Access Compliance Report Public Rights-of-Way (Curb Ramps)

Main Street: N_HEWES_ST Cross Street: WALNUT_AVE Location: SW

ADA ID: RPAT210928133814 Ramp Type: Type 4 - Parallel Initial Pass/Fail: Fail Overall Compliance: No Severity Score: 2

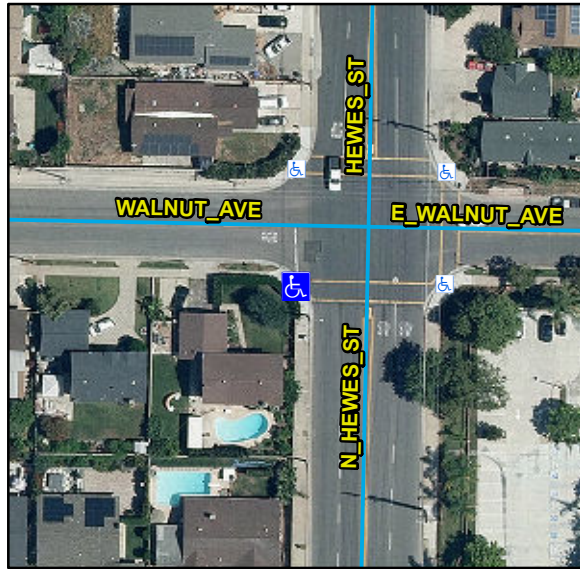
Compliance	Description	Data	Compliance	Description	Data
N/A	Ramp Length LT (in)	111	N/A	Ramp Length RT (in)	93
Yes	Ramp Width LT (in)	79	Yes	Ramp Width RT (in)	82
Yes	Ramp Run Slope LT (%)	6.3	Yes	Ramp Run Slope RT (%)	6.1
No	Ramp Cross Slope LT (%)	3.3	Yes	Ramp Cross Slope RT (%)	0
N/A	Landing Present	N/A	N/A	DWS Provided	N/A
N/A	Landing Length (in)	N/A	N/A	DWS Contrast	N/A
N/A	Landing Width (in)	N/A	N/A	DWS Length (in)	N/A
N/A	Landing Run Slope (%)	N/A	N/A	DWS Full Width	N/A
N/A	Landing Cross Slope (%)	N/A		DWS Offset Type	N/A
N/A	Landing Movement Obstructed?	N/A	N/A	DWS Offset Left (in)	N/A
	Landing Movement Type	N/A	N/A	DWS Offset Right (in)	N/A
N/A	Landing Shared	N/A			
N/A	Clear Space	Yes			
N/A	Clear Space To Crosswalk (in)	N/A			
N/A	Marked Crosswalk 1	No	N/A	Marked Crosswalk 2	Yes
	Crossing 1 Direction	E		Crossing 2 Direction	N
	Marked Crosswalk 1 Width (in)	N/A		Marked Crosswalk 2 Width (in)	120

Remove & Replace Curb Ramp With Two New Directional Ramps or Equivalent.

R304.5.3, STD 1115
